**Ecologist's Final Report - Critical Review and Assessment of the  
Flora and Fauna Chapter of the Environmental Impact Statement,  
and the Natura Impact Statement as regards "Case PA0040 –  
Donegal Windfarm" lodged by Planree Ltd., including additional  
information submitted**

**Prepared for An Bord Pleanála (ABP) by Forest, Environmental Research and Services (FERS)  
Limited**

**October 2015**

**Figure 1: Map indicating location of Lough Mourne relative to proposed development**

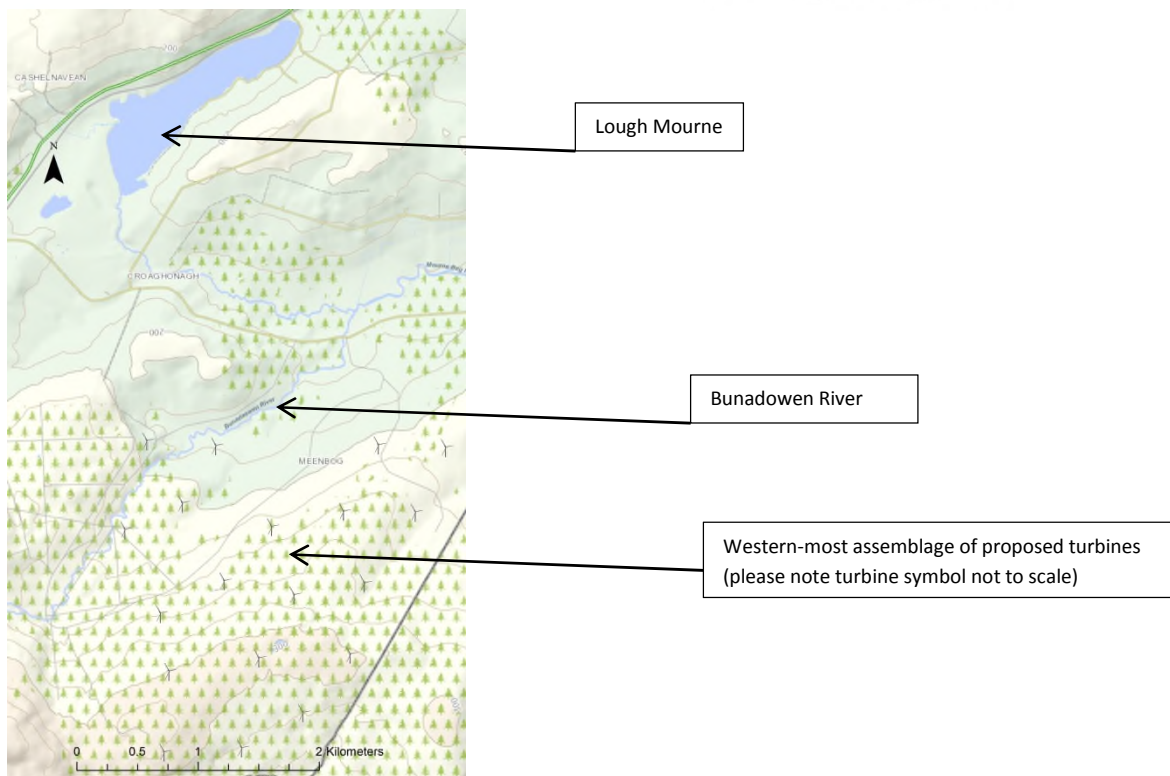
There is major potential cumulative impact on hydrology that does not appear to have been addressed by the authors of the EIS. The EIS has not taken cognisance of the plan of Donegal Co. Council (Bord Reference Number PL05.EL.2039) to “...increase abstraction of water from Lough Mourne to meet increased demand for water by the growing population of Donegal. It is proposed to raise the level of Lough Mourne by approximately 4.5 metres by constructing two dams and diverting flows from the Bunadaowen River into Lough Mourne...”. Lough Mourne, an existing public water supply source, is located on the south-east side of the N15, approximately 2 km from the nearest turbine within the proposed development. The Bunadaowen River currently discharges to the Mournebeg River, which drains Lough Mourne (see Figure 1). The cumulative impact of the proposed development on hydrology in concert with the water impoundment at Lough Mourne has not been addressed. It must also be noted that there may be a potential public health issue (in the form of the potential contamination of a public water supply) that has not been addressed in the EIS.

Taking into account the additional data supplied (and recognising that the author is not an authority on hydrology), relevant concerns appear to have been addressed in the additional information supplied.

Figure 2: Map indicating location of proposed replanting lands at Glantane Beg, Co. Cork (contract CN72161) in relation to SPAs designated for Hen Harrier.

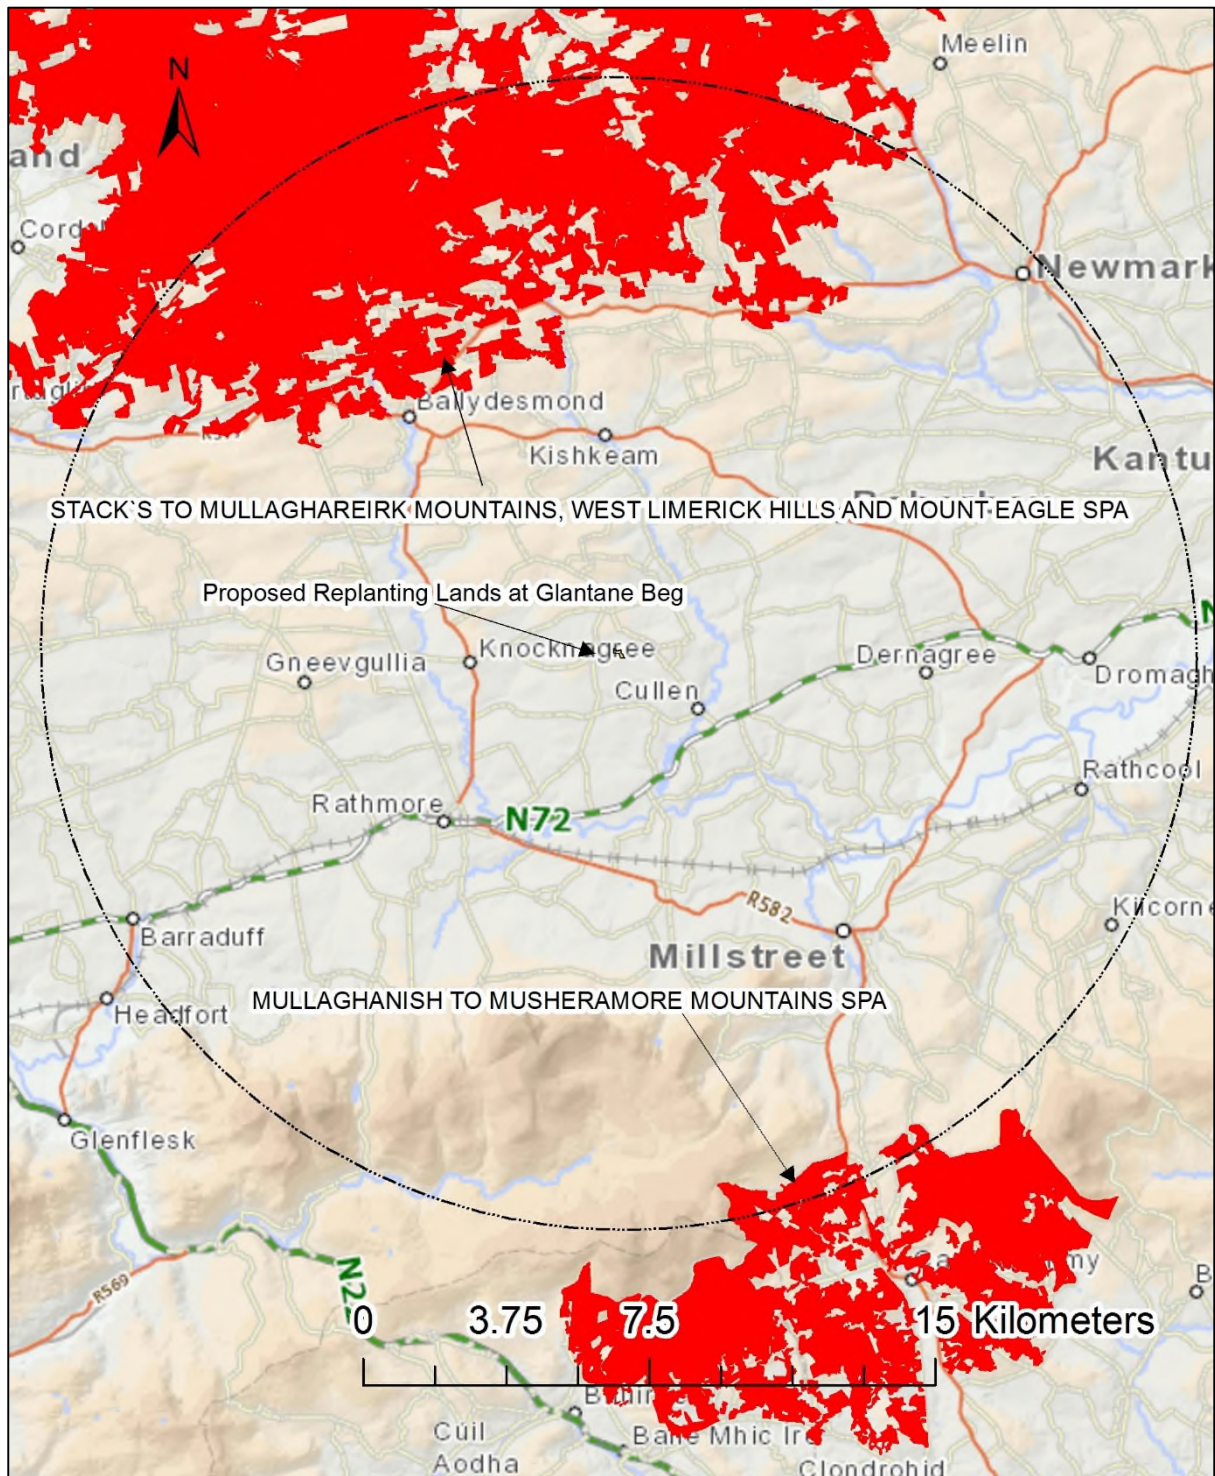
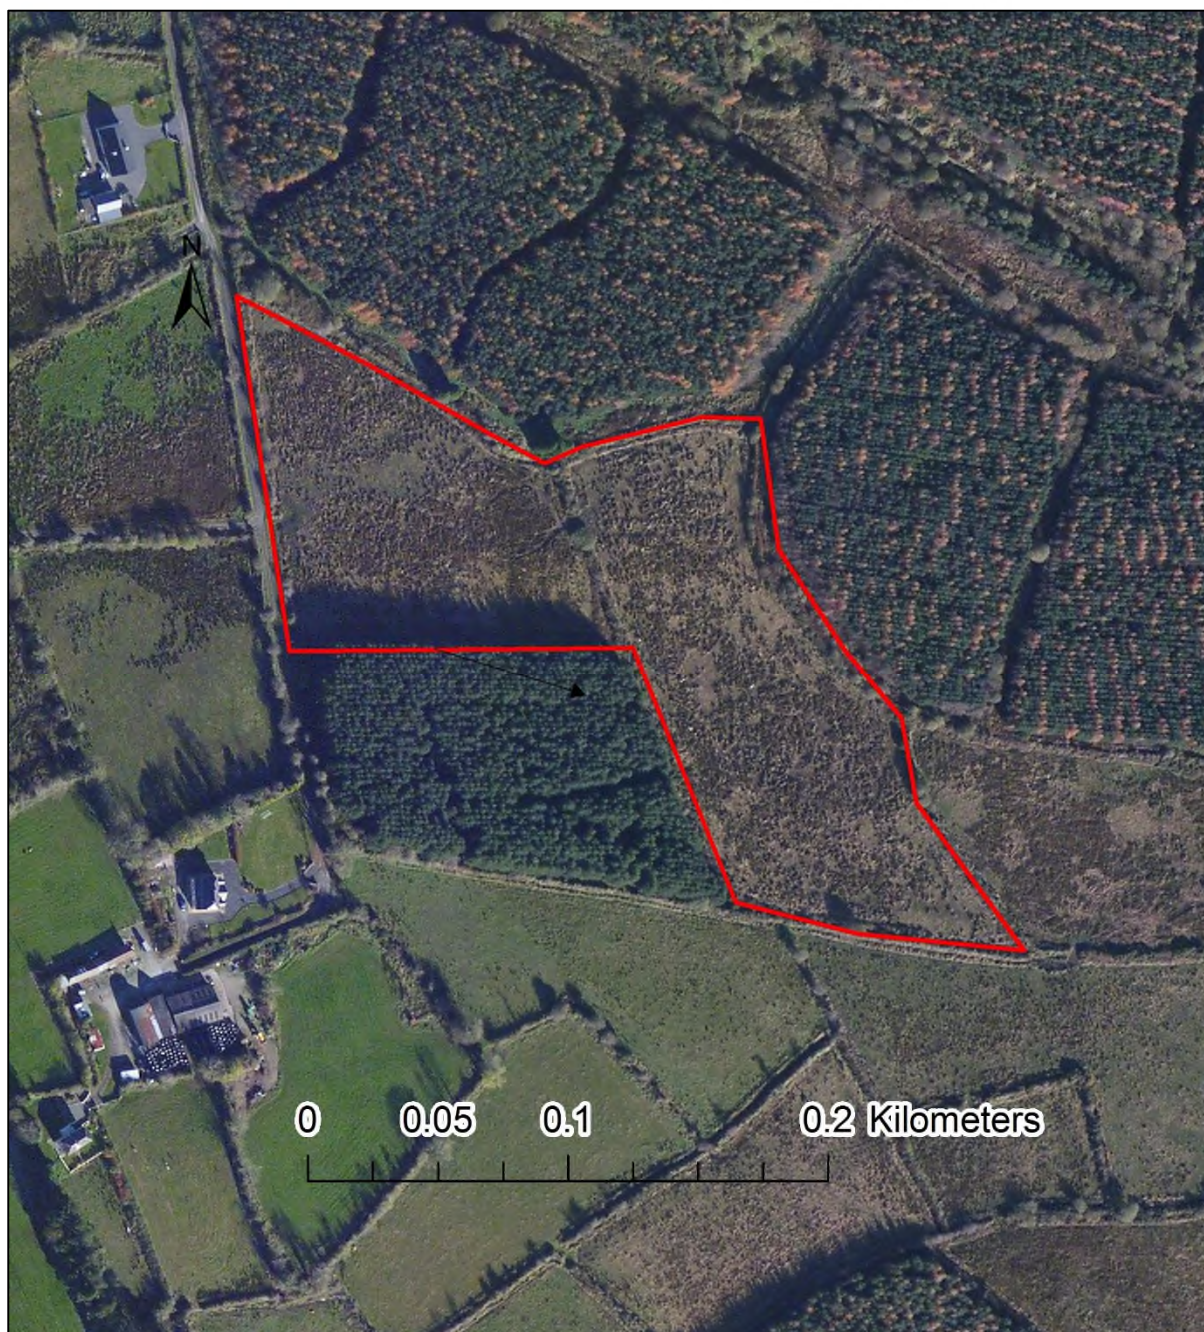
The choice of proposed replanting lands would appear to illustrate a lack of Ecological Due Diligence, given the proximity of all eight proposed sites to Natura 2000 sites (all proposed replanting sites are within 5 km of at least one Natura 2000 site) and in particular, the proximity of the Glantane Beg site to two of only six Special Protection Areas in the Republic of Ireland designated for Hen Harrier.
